COUNTY OF SAN LUIS OBISPO DEPARTMENT OF PLANNING AND BUILDING STAFF REPORT

TRACT 2598 SUB2003-00307

Proposal by Anderson Family Trust/EMK for a Vesting Tentative Tract Map (TR-2598) to subdivide an existing 4.32 acre parcel into six parcels of 0.49, 0.51, 0.58, 0.59, 1.03 and 1.08 acres each. The project is located at 6393 Cressey Street, immediately north of 4th Street, approximately 350 feet northwest of State Highway 229 in the community of Creston in the El Pomar/Estrella planning area.

Deny Tentative Tract 2598 based on the findings listed in Exhibit A.

TENTATIVE TR 2598

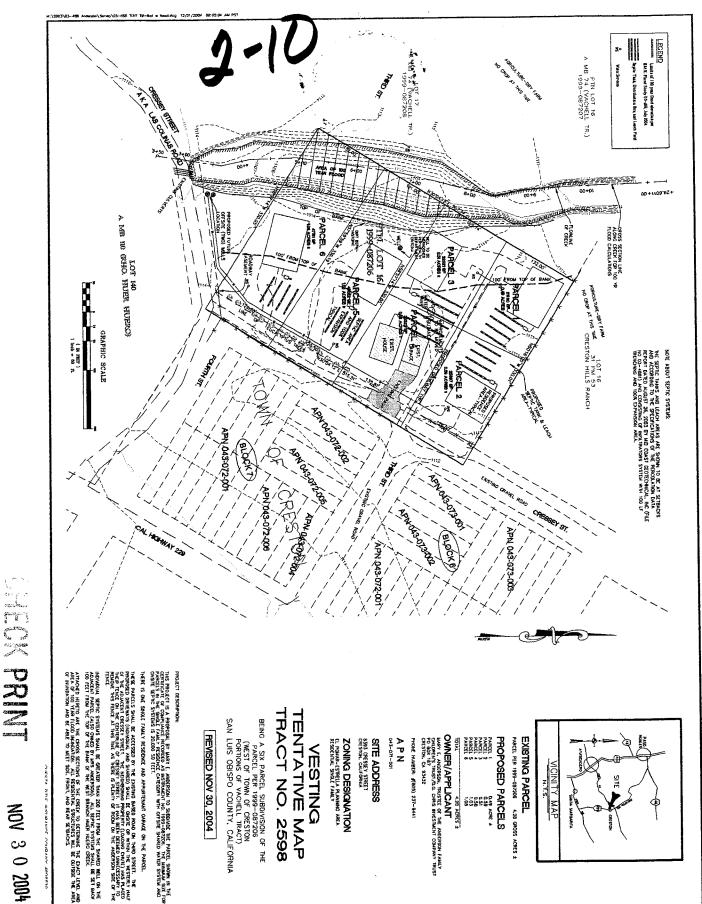
A 50 foot setback from the top of the bank bisects the designated building sites on proposed parcels 3 and 6 and cuts off a part of the designated building site on proposed parcel 5. Proposed parcels 3 and 6 do not have sufficient area to construct a residence and septic system whiling staying out of setback areas. No adjustment is possible in this case as a reduced project alternative can be designed that meets the setback requirements for new development.

- The building sites designated on the proposed tentative map for parcels 1, 3, 5 and 6 are located within the required 50 foot setback from the top of the bank of the blueline stream. Therefore, the proposed project is not consistent with the requirement that all new development be setback a minimum of 50 feet for the top of the bank of the stream.

- E. The site is not physically suitable for the type of development proposed because the proposed parcels cannot be developed in compliance with the planning area standards requiring 50 foot creek setbacks. Also, septic systems must be setback a minimum of 100 feet from the top of the bank of the blueline stream. Septic system in proper locations will not allow for development to take place outside of the 50 foot development setback area.
